File FPP-1996-056

Name: Helena Subdivision -2776 and 2789 Unawweep Avenue

PETITIONERS RESPONSE LETTER to REVIEW COMMENTS
for FINAL APPROVAL of HELENA SUBDIVISION

DATE: March 26, 1996
TO: Wayne Lizer
Michael Queally
FROM: Bill Nebeker *BN*
Senior Planner
SUBJECT: Helena Final Subdivision

GRADING AND DRAINAGE PLAN

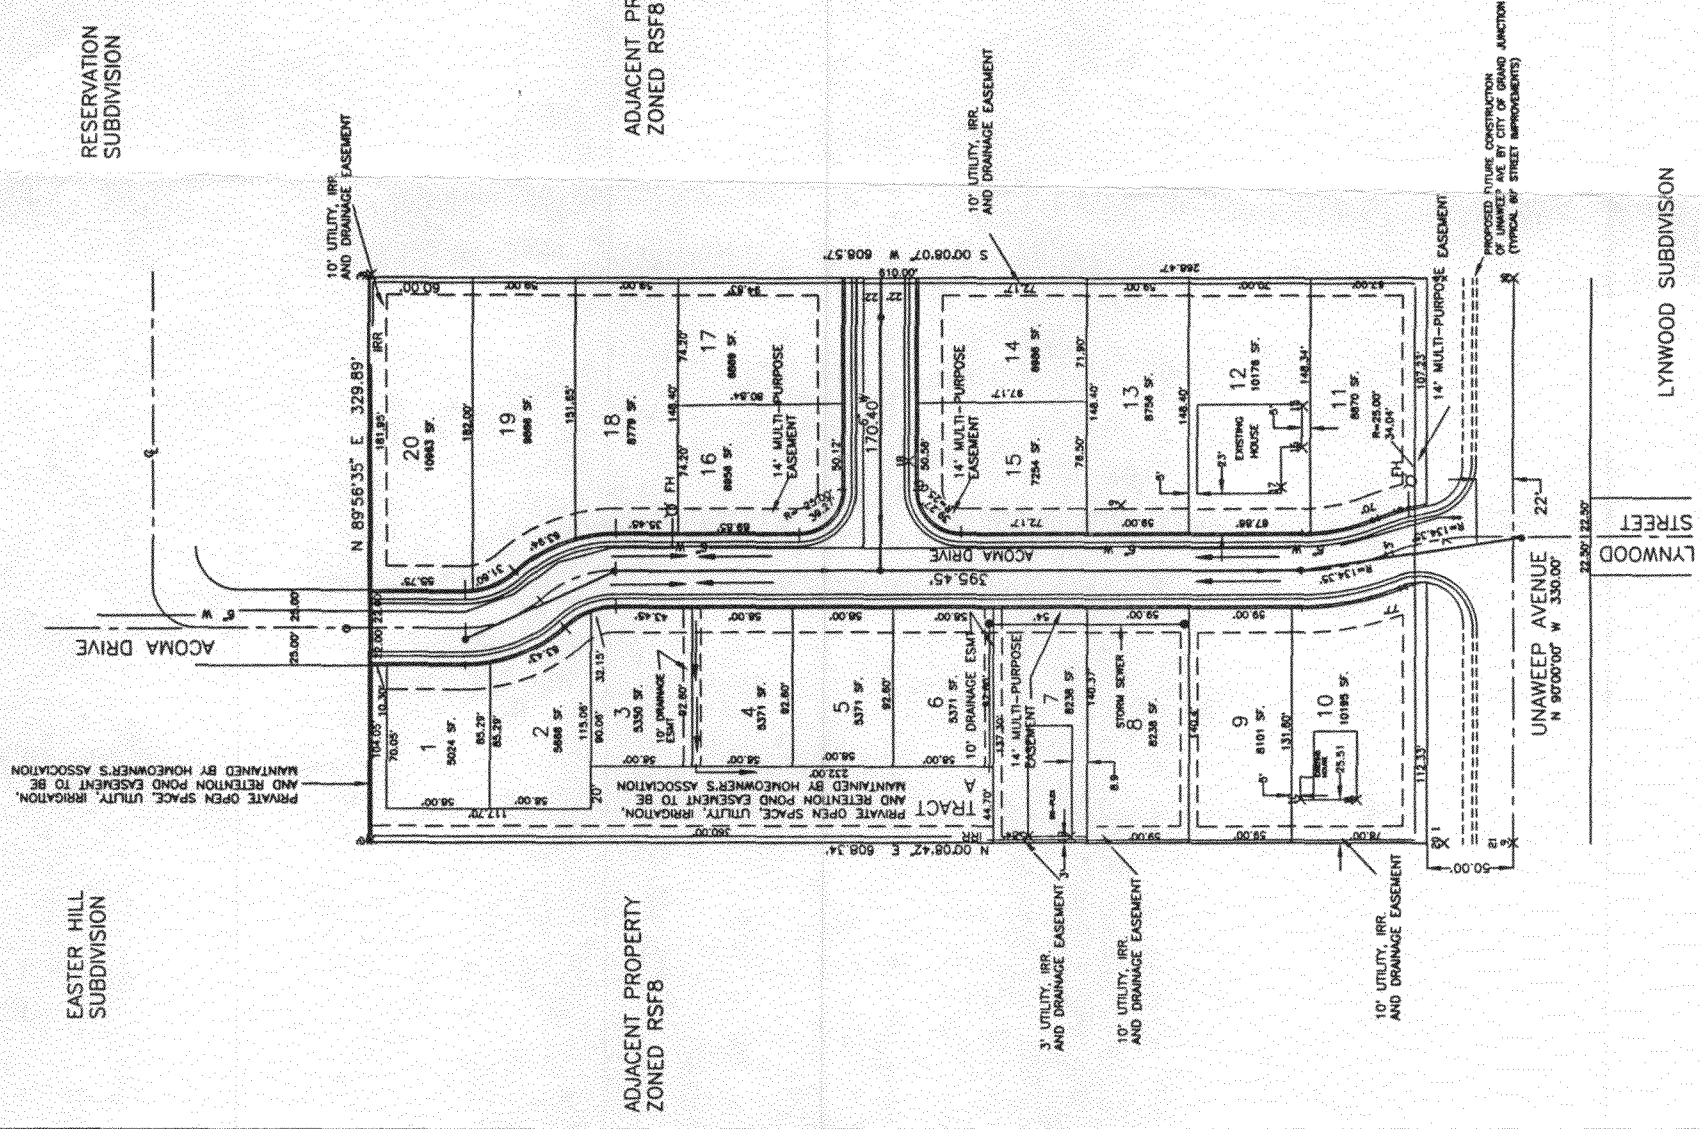
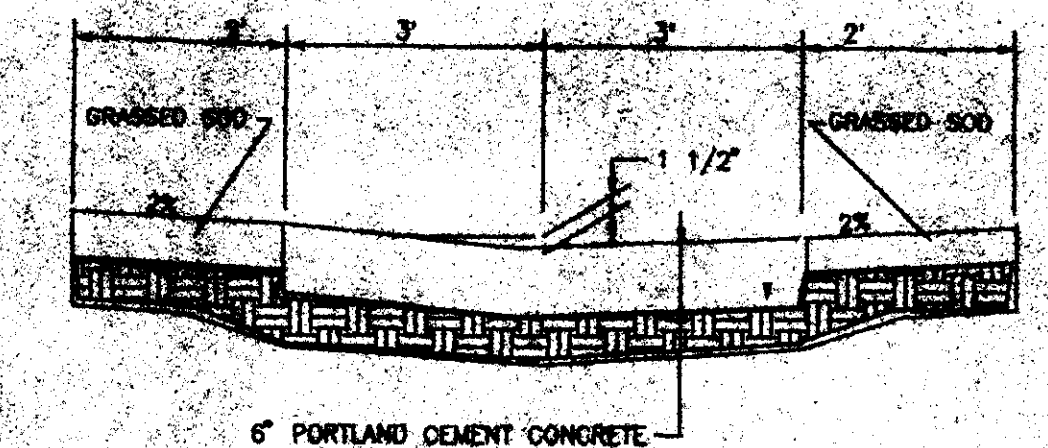
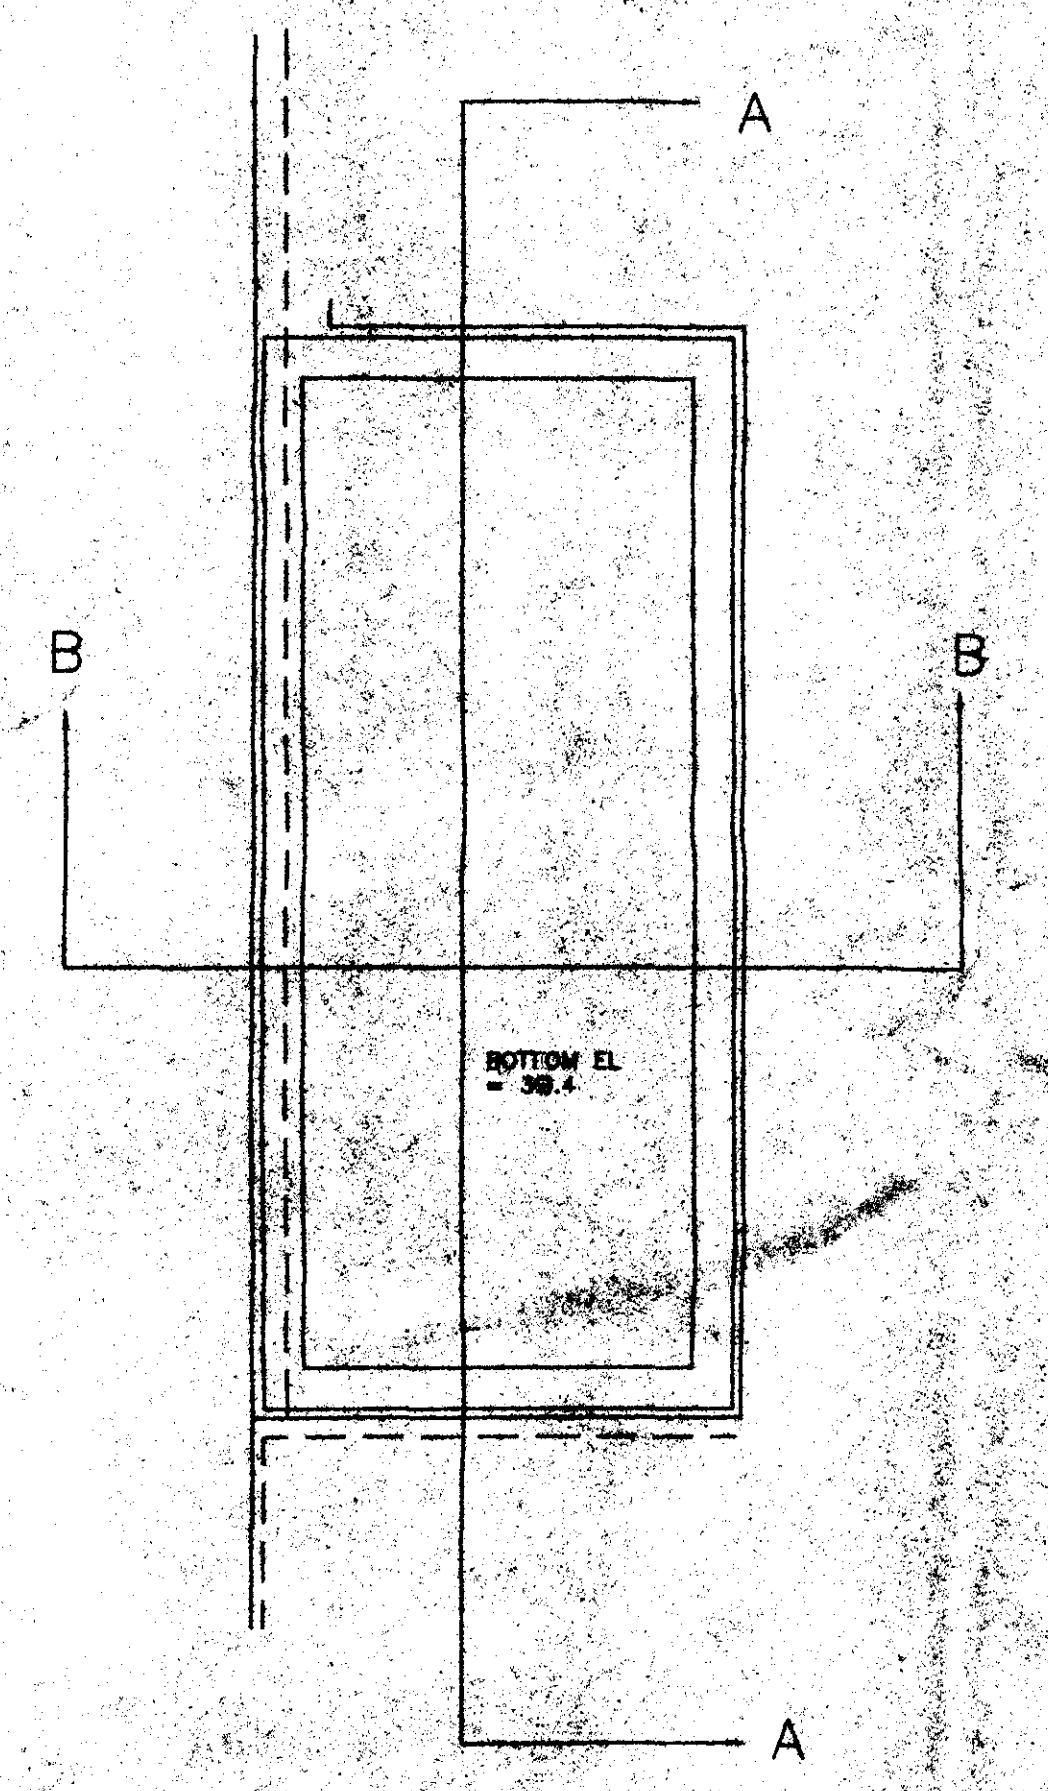
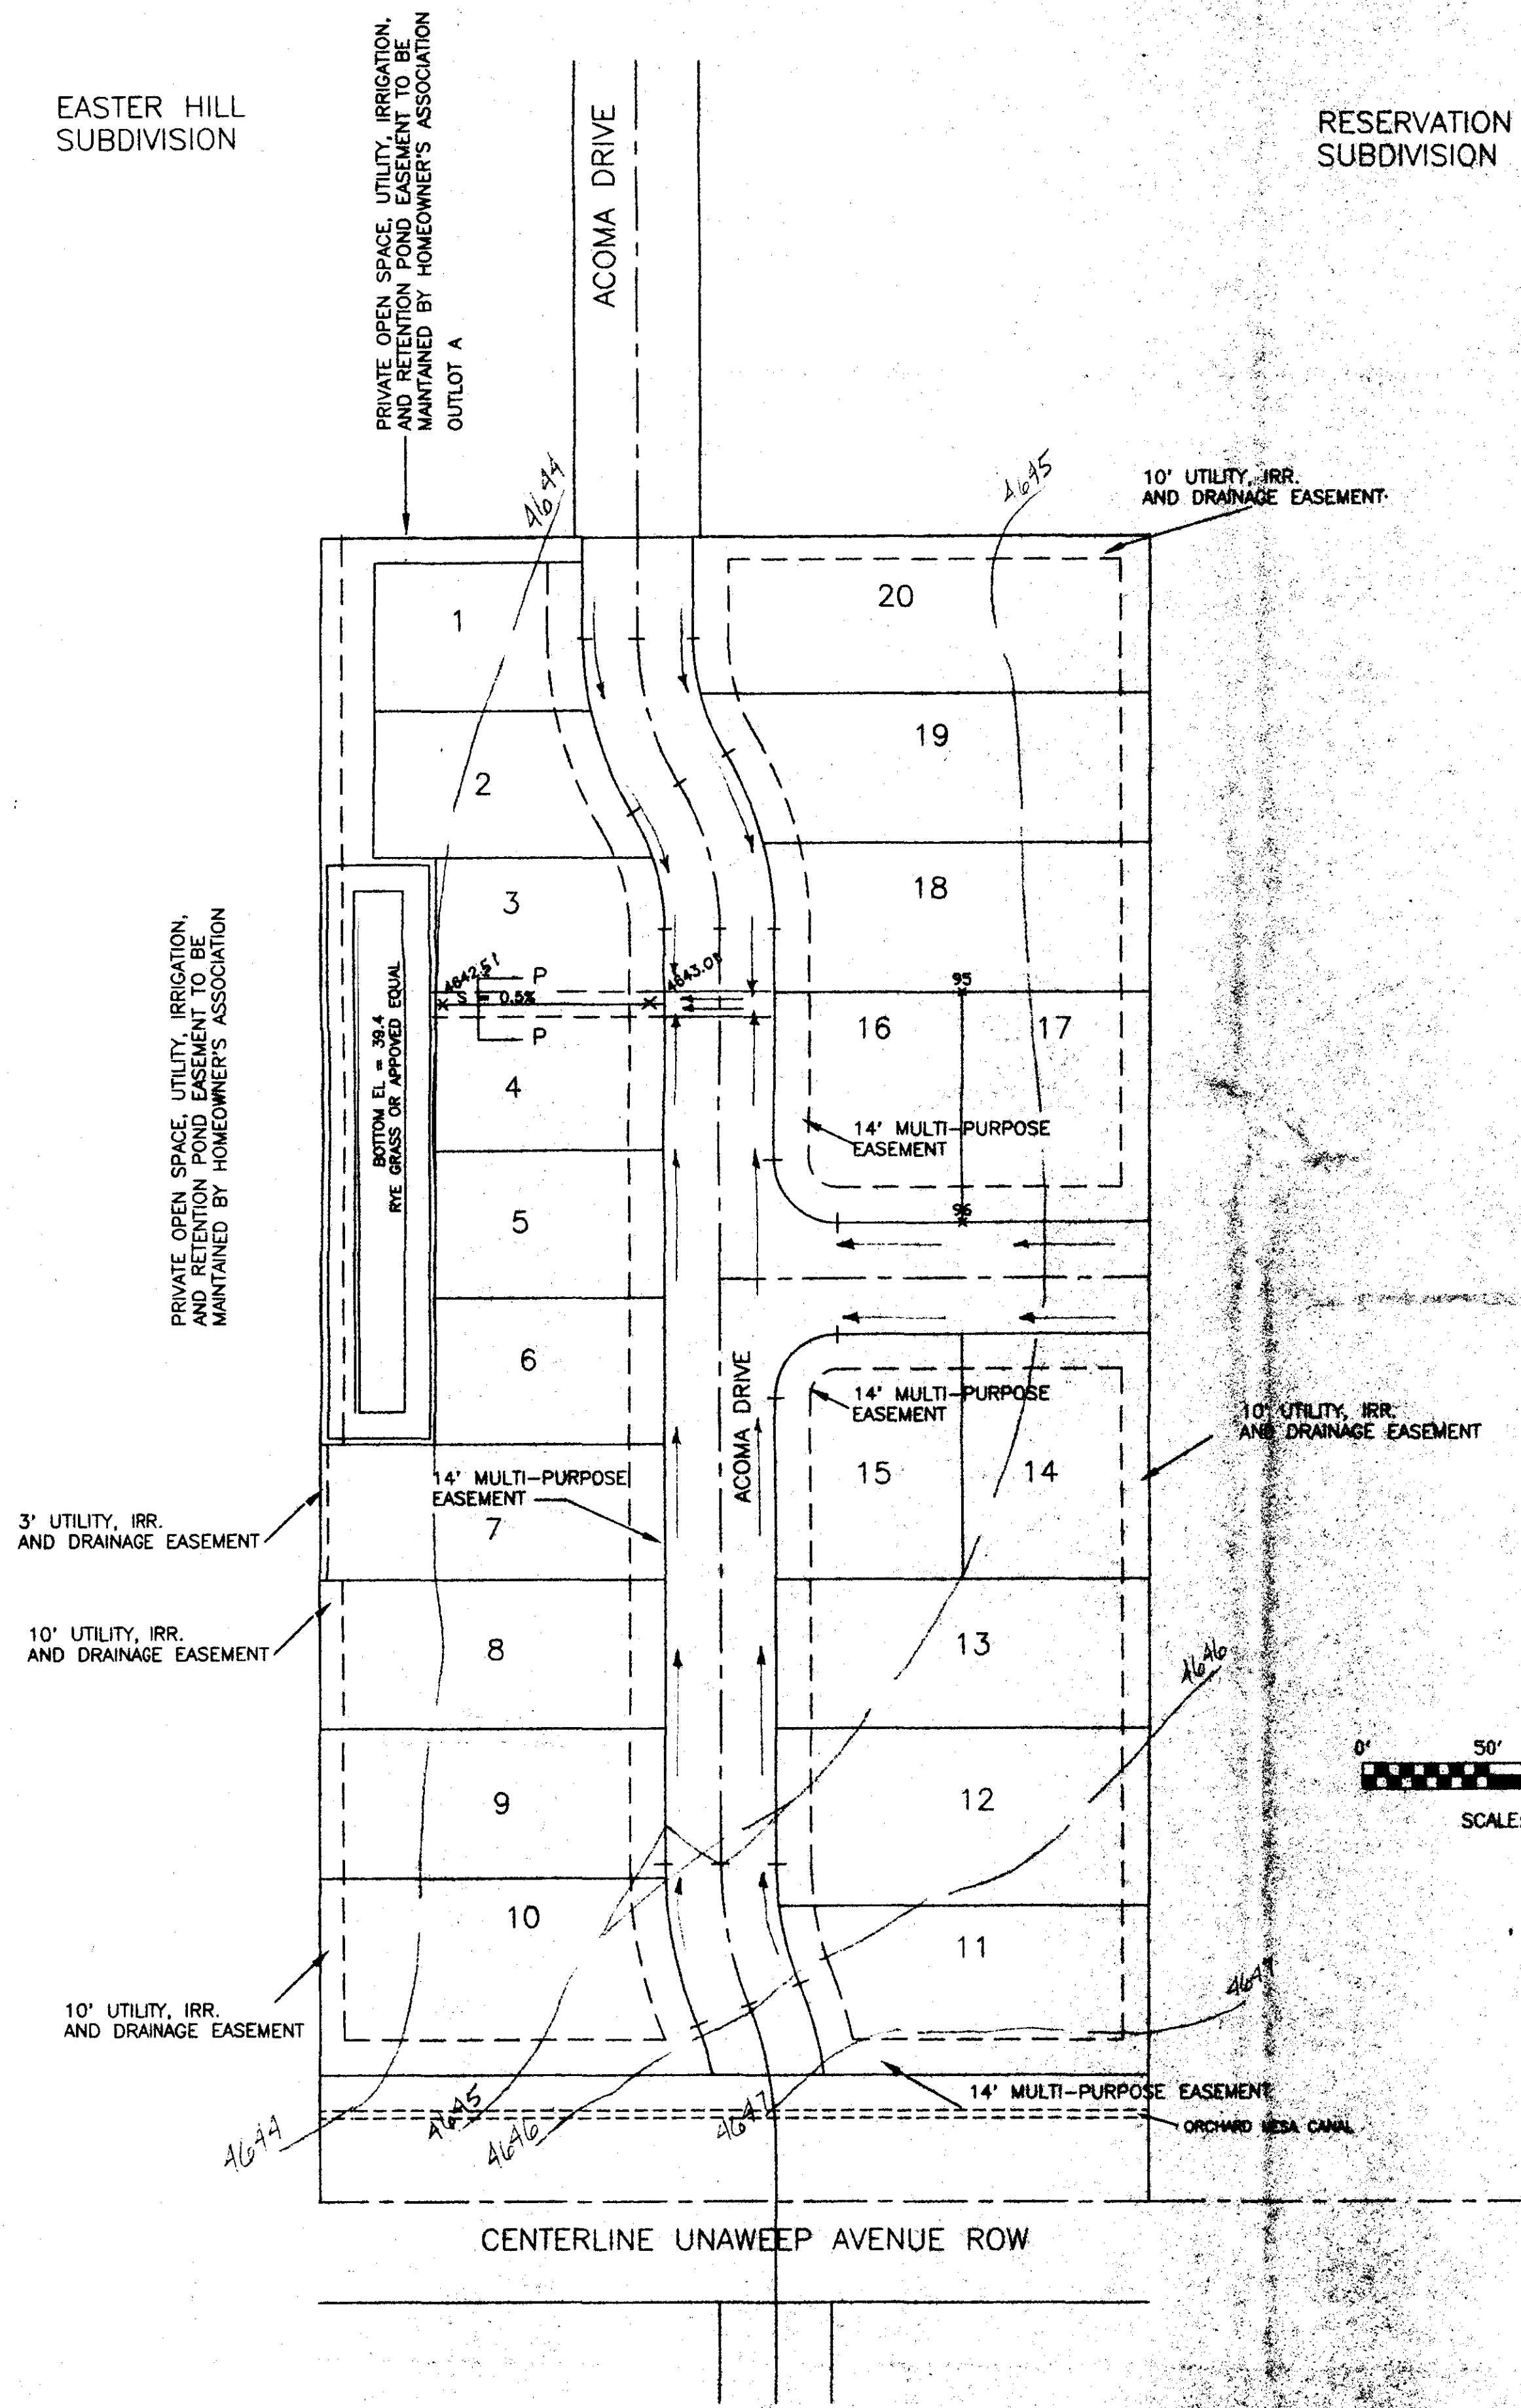
An easement is being provided for future pedestrian/bicycle access to the west. The plat must be revised to show a 10 foot wide pedestrian easement within Tract A, directly north of the north lot line of lot 1. The latest revisions showed the entire tract as a pedestrian easement. An 8 foot wide concrete sidewalk must be provided within the pedestrian easement to the west property line. A section drawing shall be provided on the street plans for this path and the cost of it included in the development improvements agreement.

Tract A which is reserved for drainage and private open space has not been identified consistently on the plat and improvement plans. Some plans label it as an outlet; others as a tract. It should be labeled as Tract A on the plat, in the dedication statement and on improvement plans. The labeling of Tract A as private open space, utility, irrigation and retention pond easements must also be consistent with the dedication statement. Evidence must be submitted prior to final plat recordation that shows that a homeowner's association has been formed to maintain the tract.
